Village of Cassopolis

CWSRF Interceptor Force Main Replacement

ADDENDUM 1

June 12, 2026

Sheet SR-7.1-2 – E. Division Street Surface Restoration Plans Sta. 0+00 to 10+00

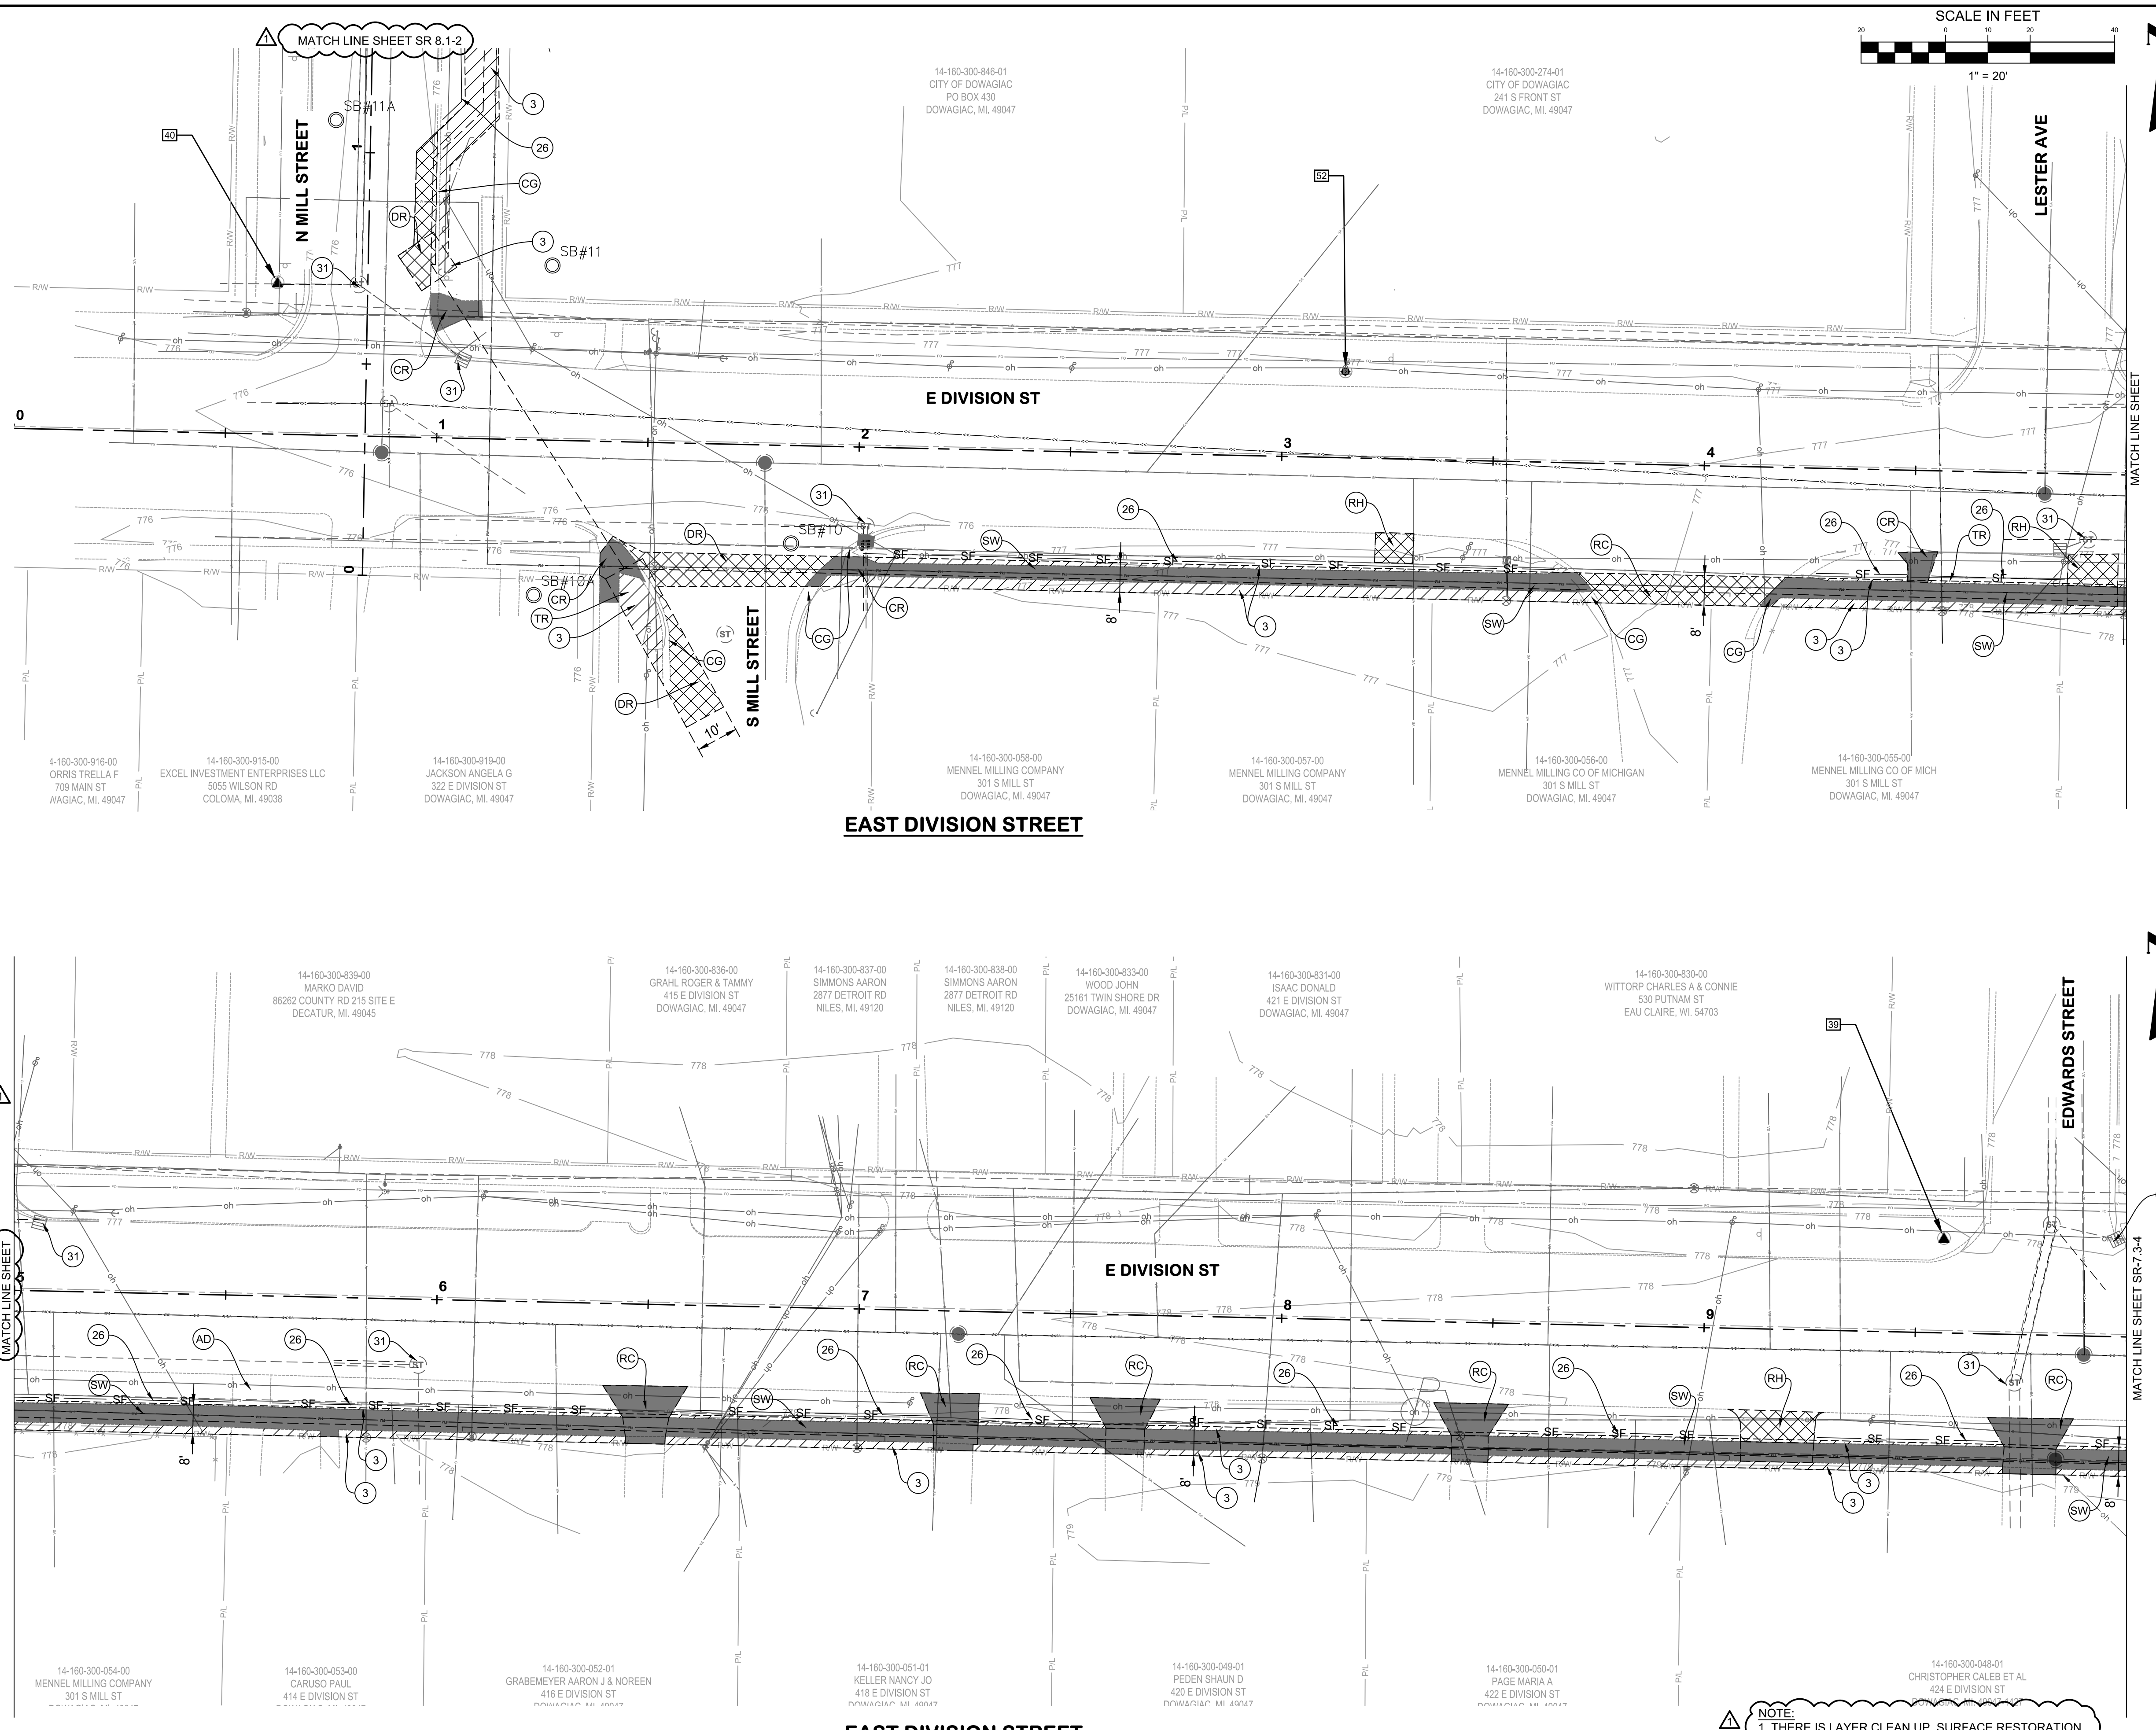
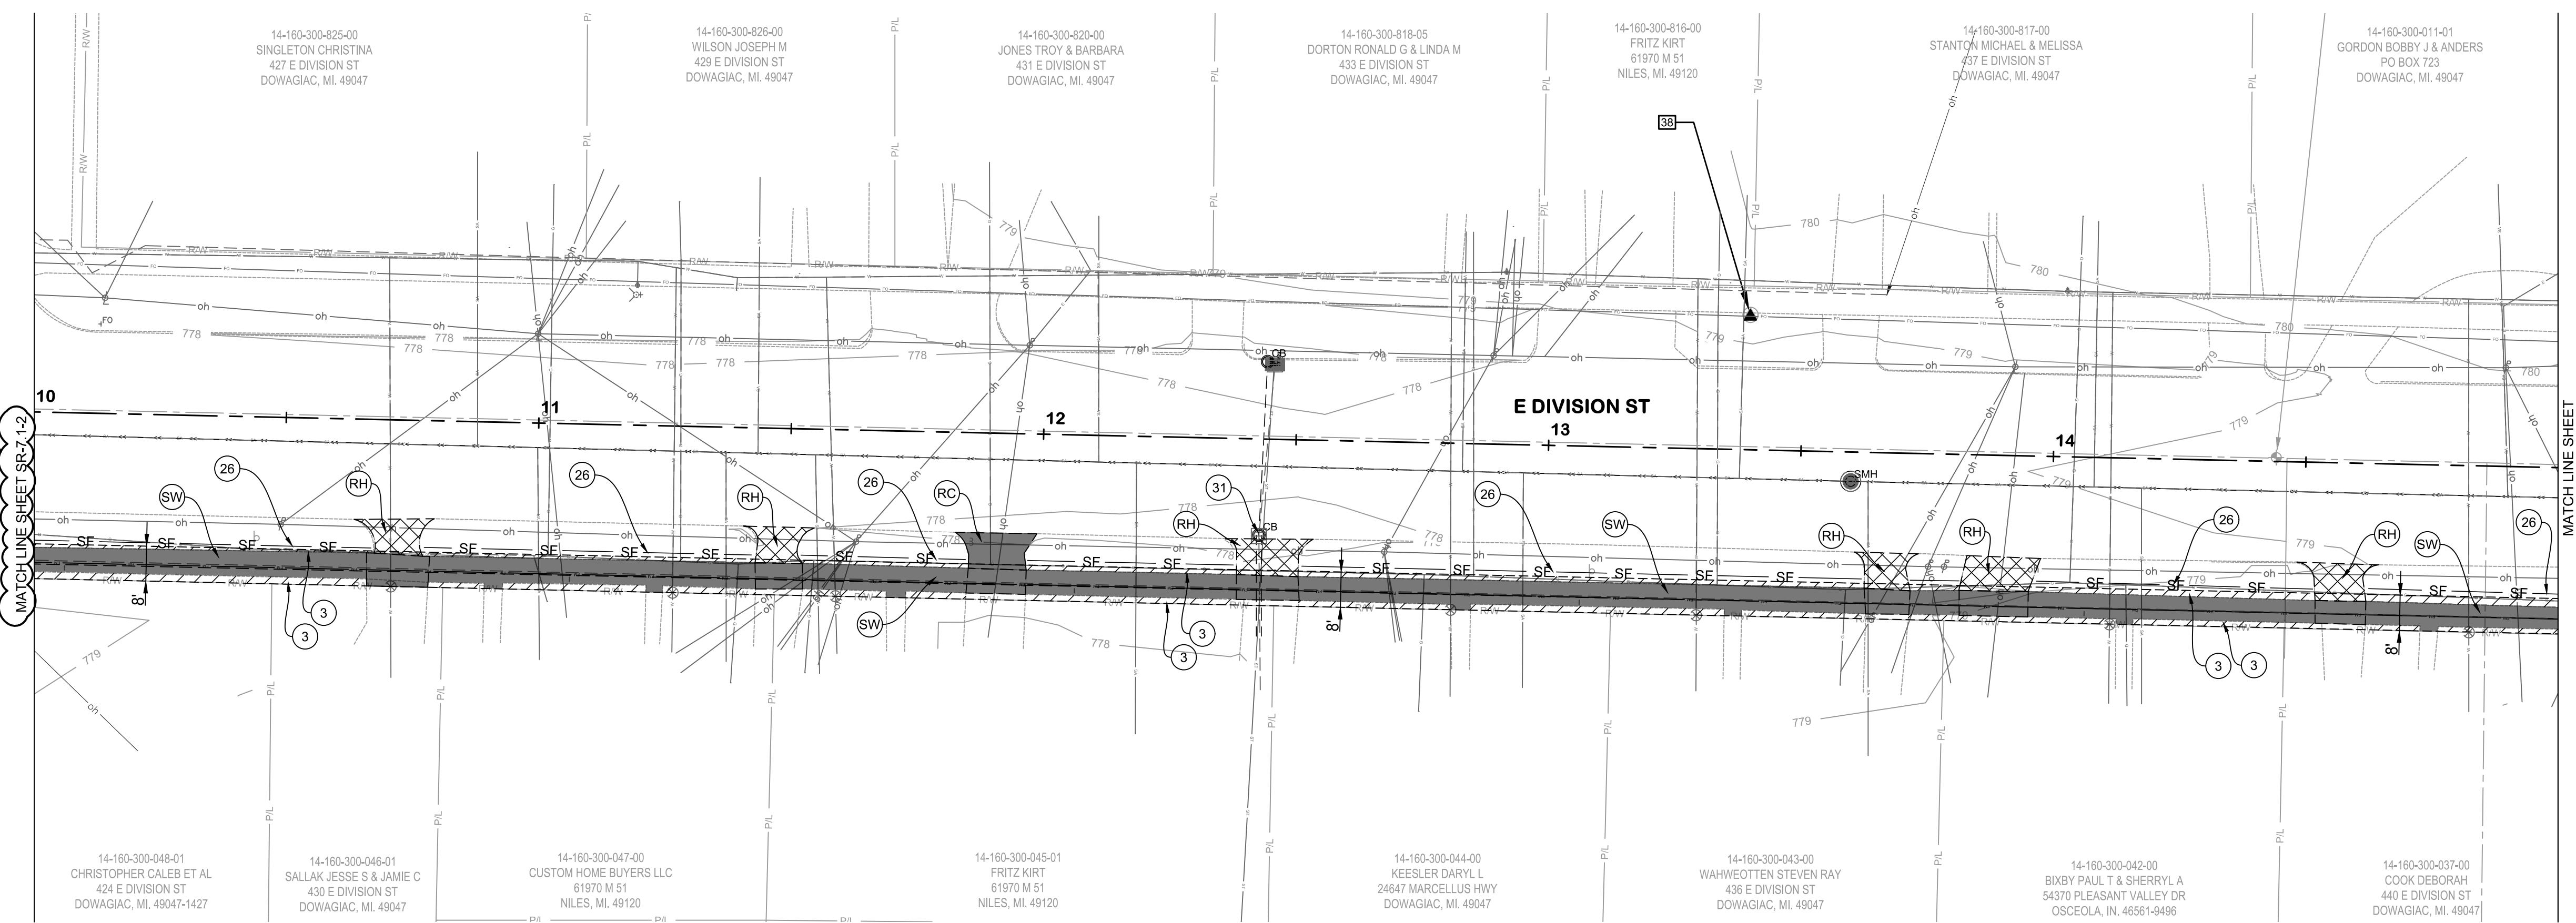
There is layer clean up, tree added, and match lines added to this sheet. Replace the sheet with the provided Sheet SR-7.1-2 included with Addendum 1.

NOTE:
 1. THERE IS LAYER CLEAN UP, SURFACE RESTORATION HATCH LEGEND, TREE ADDED, AND MATCH LINES ADDED TO THIS SHEET. REPLACE THE SHEET WITH THE PROVIDED SHEET SR-7.1-2 WITH ADDENDUM 1

Sheet SR-7.3-4 – E. Division Street Surface Restoration Plans Sta. 10+00 to 20+00

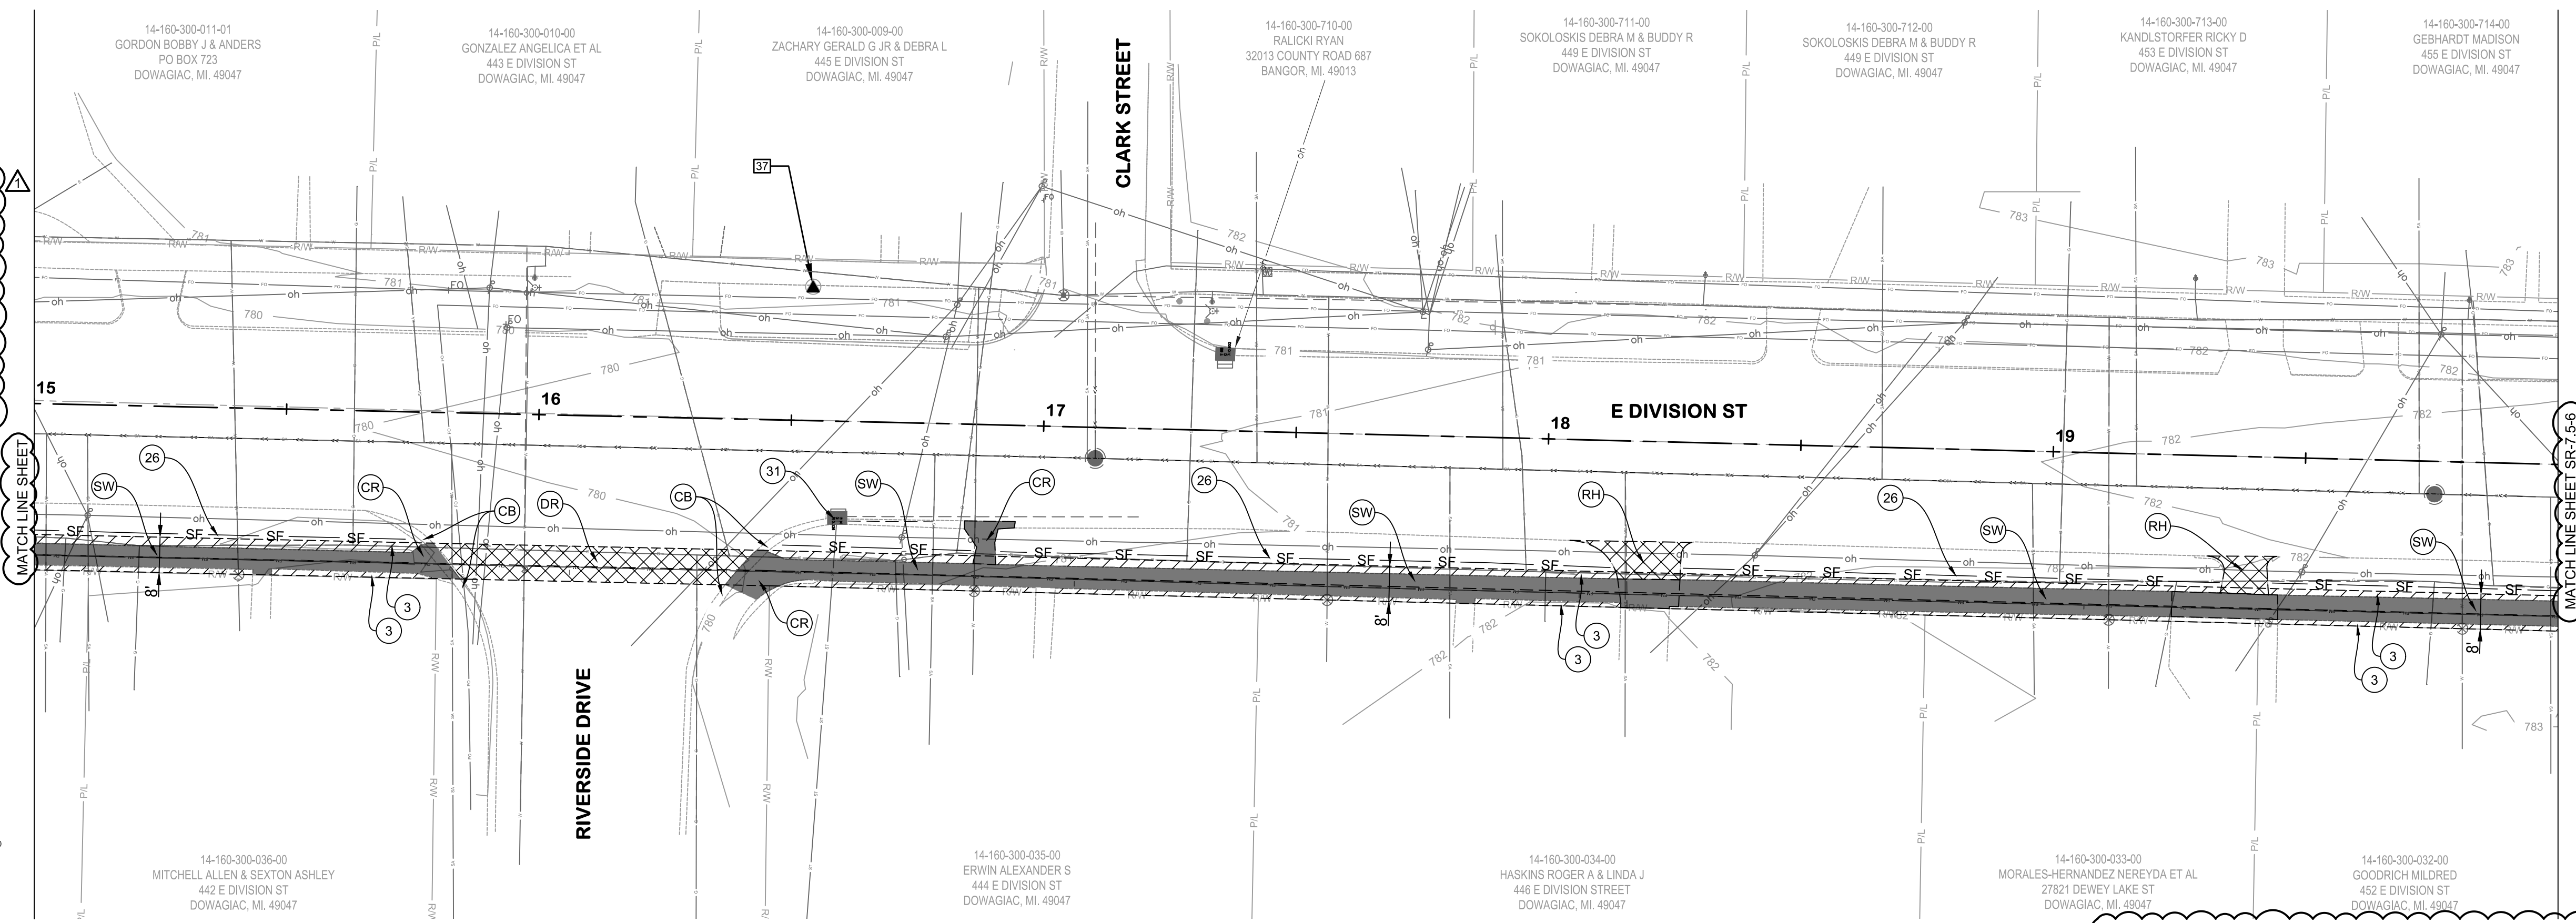
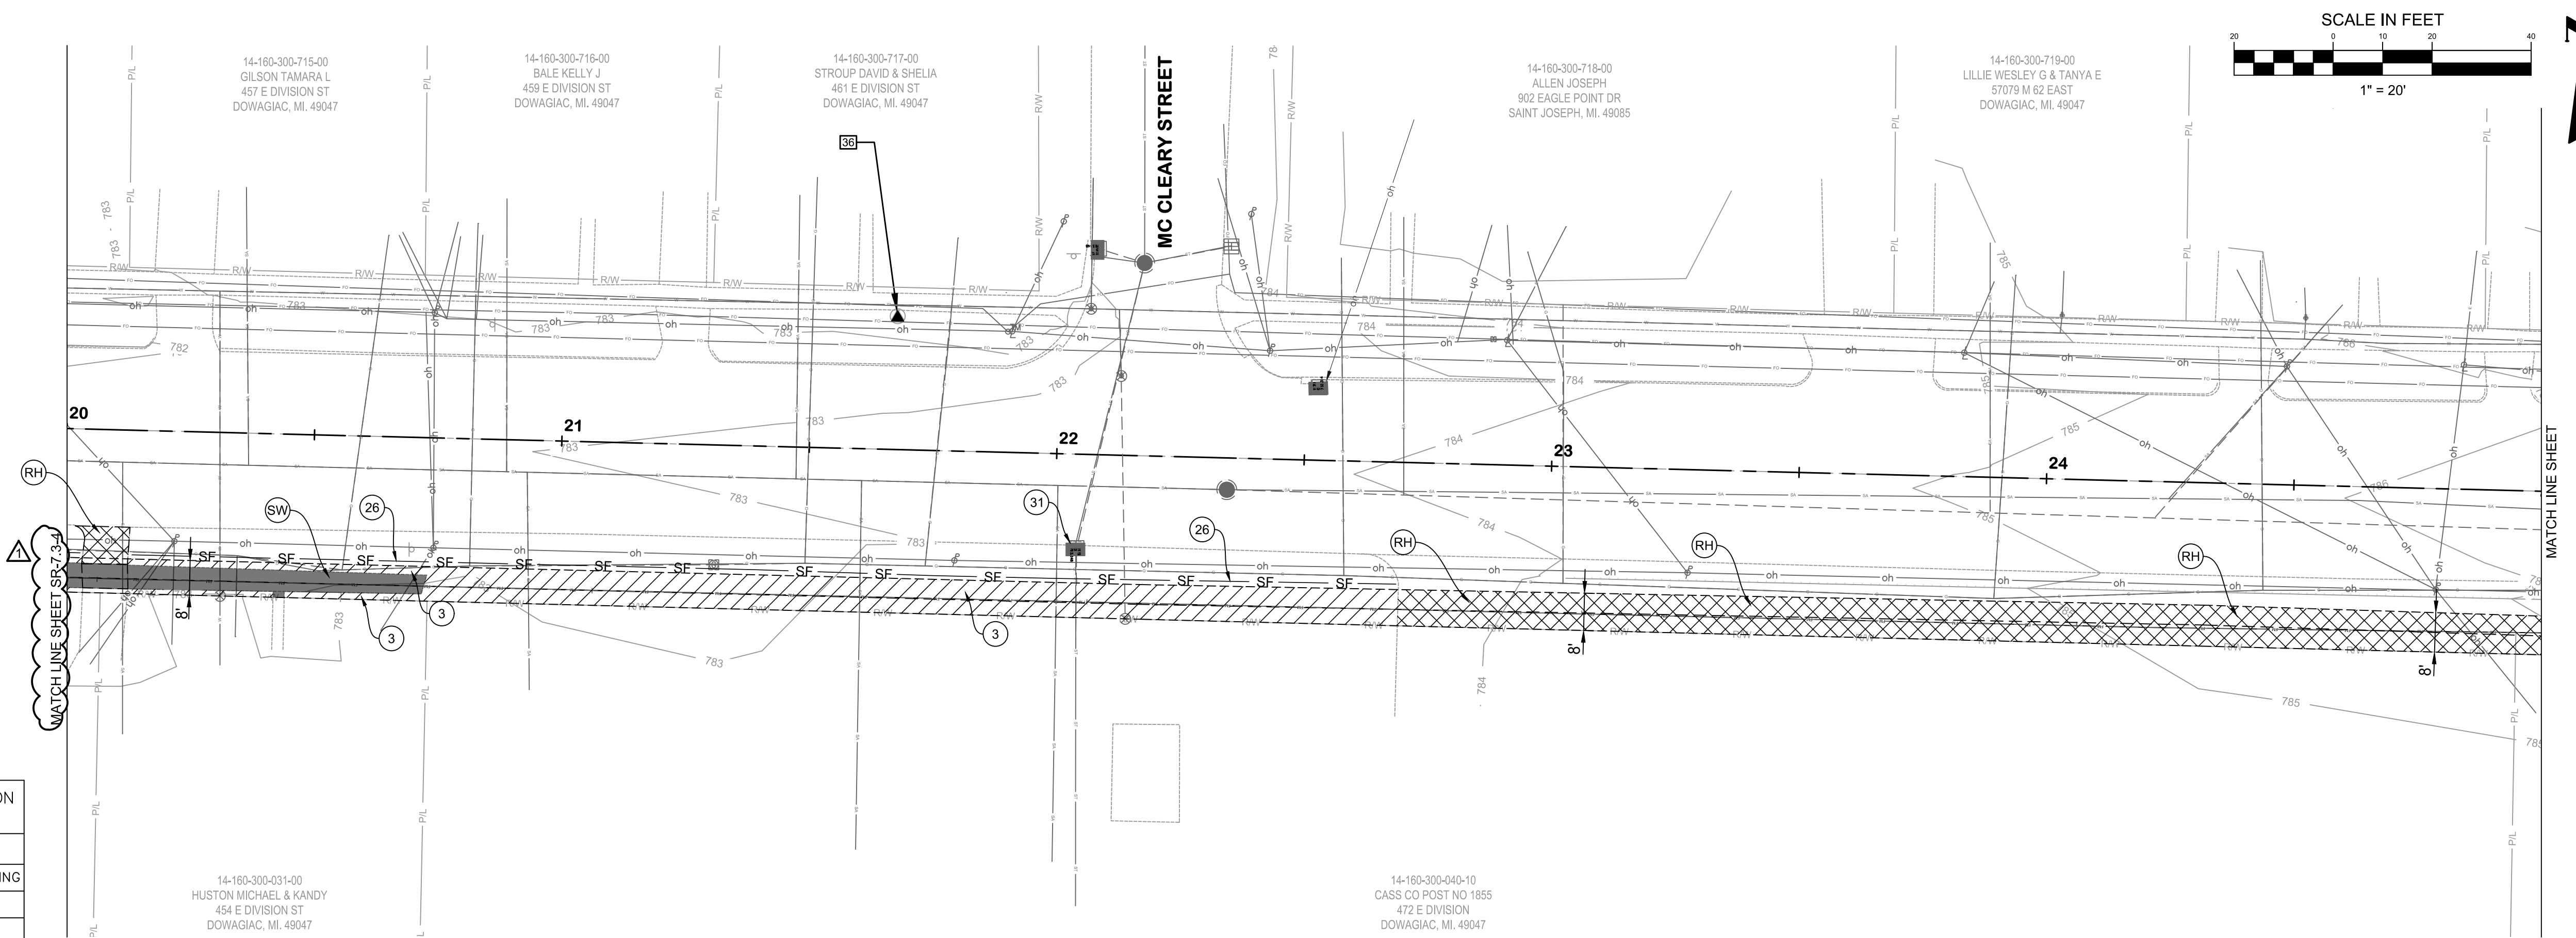
There is layer clean up and curb replacement added to this sheet. Replace the sheet with the provided Sheet SR-7.3-4 included with Addendum 1.

NOTE:
1. THERE IS LAYER CLEAN UP, SURFACE RESTORATION HATCH LEGEND, MATCHLINES AND CURB REPLACEMENT ADDED TO THIS SHEET. REPLACE THE SHEET WITH THE PROVIDED SHEET SR-7.3-4 WITH ADDENDUM 1.
